**BEFORE THE NORTH CAROLINA UTILITIES COMMISSION  
DOCKET NO. E-7, SUB 1214**

**In the Matter of:  
Application of Duke Energy Carolinas,  
LLC for Adjustment of Rates and  
Charges Applicable to Electric Service  
in North Carolina**

) **TESTIMONY OF DENNIS**  
) **STEPHENS ON BEHALF OF THE**  
) **NORTH CAROLINA JUSTICE**  
) **CENTER, NORTH CAROLINA**  
) **HOUSING COALITION, NATURAL**  
) **RESOURCES DEFENSE COUNCIL**  
) **AND SOUTHERN ALLIANCE FOR**  
) **CLEAN ENERGY AND THE**  
) **NORTH CAROLINA**  
) **SUSTAINABLE ENERGY**  
) **ASSOCIATION**

**February 18, 2020**

1 *Figure 1: Relationship between Grid Investment and Reliability for DEC*

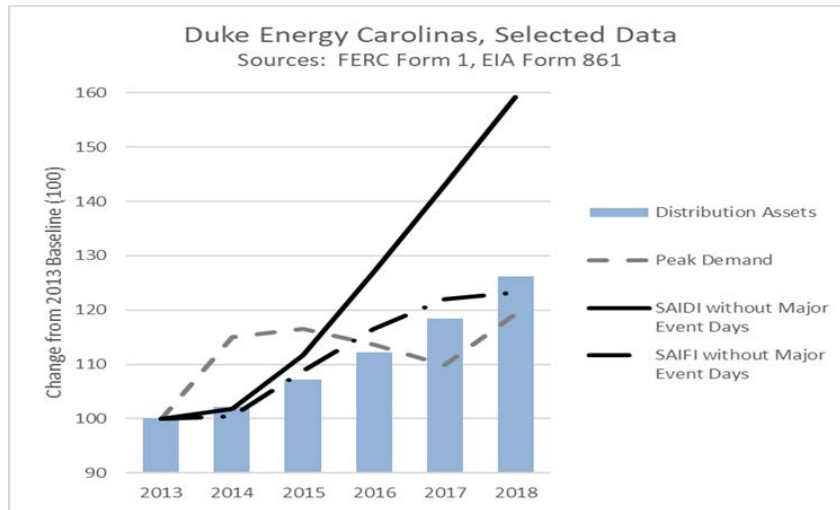
5 As shown in Figure 1, DEC’s SAIDI and SAIFI performance have  
6 deteriorated almost 60% and more than 20%, respectively, since 2013 despite grid  
7 investment growth 37% greater than peak demand growth. As shown in Figure 2,  
8 DEP’s SAIDI and SAIFI performance have deteriorated almost 50% and more

3 *Figure 2: Relationship between Grid Investment and Reliability for DEP<sup>9</sup>*

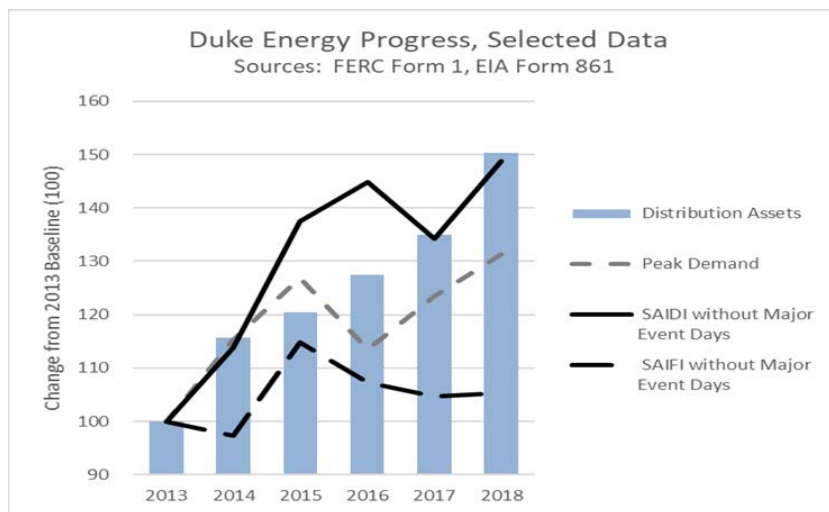
1 than 5%, respectively, since 2013 despite grid investment growth 61% greater  
2 than peak demand growth.
